**REVISED ACTIONS, CONDITIONS, AND FINDINGS TO CPC-2015-4184-GPA-ZC-BL-SPR,  
AND VTT-73939-CN-2A, 9433 N. SEPULVEDA BOULEVARD AND 15500-15508 WEST  
PLUMMER STREET; COUNCIL DISTRICT NO. 7; CF 17-0021, CF 17-0021-S2**

**REVISED PROJECT, ACTIONS, CONDITIONS, AND FINDINGS TO CPC-2015-4184-GPA-ZC-BL-SPR, AND VTT-73939-CN-2A**

# AMENDED VESTING TENTATIVE TRACT MAP NO. 73939

EXHIBIT E

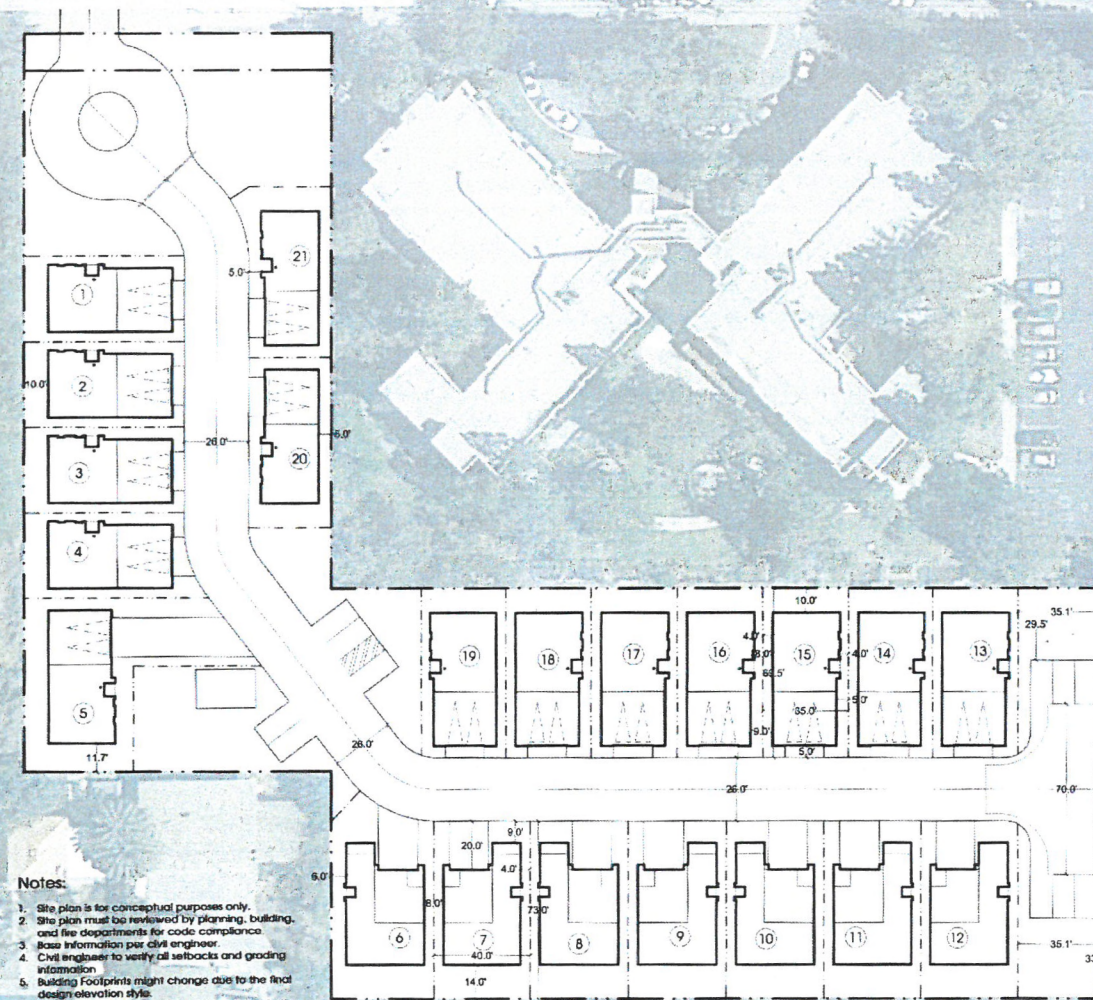
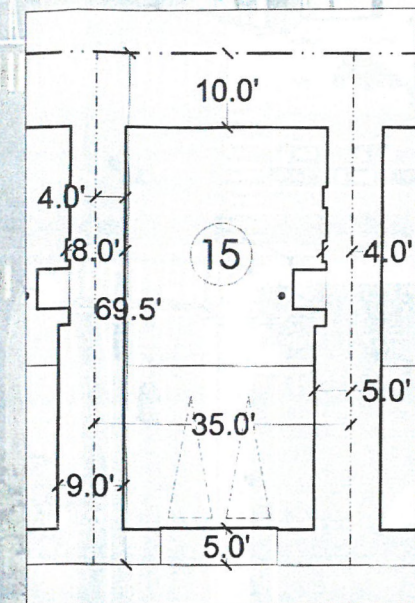
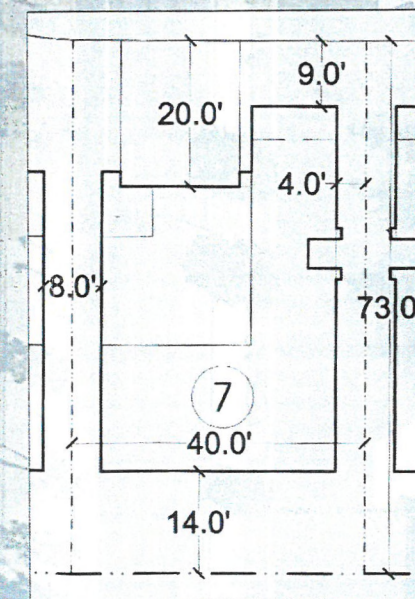
1. **Site Development.** Except as modified herein, the project shall be in substantial conformance with the plans stamp-dated March 28, 2017 and materials submitted by the Applicant, stamped "~~Exhibit A~~" "Exhibit E" ~~for the site plan and Exhibit B for the building elevations~~ and attached to the subject case file. No change to the plans will be made without prior review by the Department of City Planning, Valley Project Planning Division, and written approval by the Director of Planning. Each change shall be identified and justified in writing. Minor deviations may be allowed in order to comply with the provisions of the LAMC or the project conditions.

1. **Site Development. Plot/Site Plan.** Prior to the issuance of any building permits for the subject Project, detailed development plans including site and elevation plans, and including complete landscape and irrigation plans prepared by a licensed landscape architect or architect, shall be submitted for review and approval by the Department of City Planning for verification of compliance with the imposed conditions. The plans submitted to Building and Safety shall be revised in substantial conformance with this approval and shall be in substantial conformance with the plans labeled **"Exhibit E"** ~~**"Exhibit A-6"**~~, attached to the subject case file.

On March 28, 2017, the Planning and Land Use Management (PLUM) Committee heard the project and was made aware by the applicant's testimony that the project was changed from its original City Planning Commission recommended action to address the issues raised by the surrounding single-family neighborhood. The original project request includes a General Plan Amendment to the Mission Hills-Panorama City-North Hills Community Plan from the Low Residential and Medium Residential land use category to the Low Medium II Residential land use category, a Zone Change from RA-1 and R3-1 to (T)(Q)RD1.5-1, a 22-foot Building Line Removal originally established pursuant to Ordinance 99739, and Site Plan Review for the development of 50 or more residential dwelling units. The original project was reviewed as a development for a 75-unit detached residential condominium with a townhome style of 4- to 6-unit buildings spread throughout the entire site with open space park areas and an interior common access area for vehicles. The request included varying unit sizes ranging from approximately 1,190 to 1,390 square-feet and having either two (2) or three (3) bedrooms with a maximum height of three stories and 41 feet with roof top decks. The project included a total of 169 parking spaces.

On March 28, 2017, the project applicant submitted a modified project to address community concerns. At that time, the PLUM Committee directed the Department of City Planning to review and analyze the modified project. The proposed modified project will have a less significant impact than the original project or will have no change in impact from the original project. As such, the revised project will not require an Addendum, Supplemental, or Subsequent recirculated environmental mitigated negative declaration. Any change in impact resulting from the modified project, including those resulting from project density, vehicular access, traffic, grading, and height are discussed as follows:

- Density - The modified project is a like density of 75-units consisting of a 54-unit apartment building that can be built as a by-right project over the existing R3-1

Zoned portion of the project fronting on Sepulveda Boulevard. The remainder “L” shaped portion of the site consists of a 21-unit detached residential condominium project with frontage off of Plummer Street. Therefore, any impacts as a result of project density are unchanged from the previously adopted revised Mitigated Negative Declaration No. ENV-2015-4183-MND.
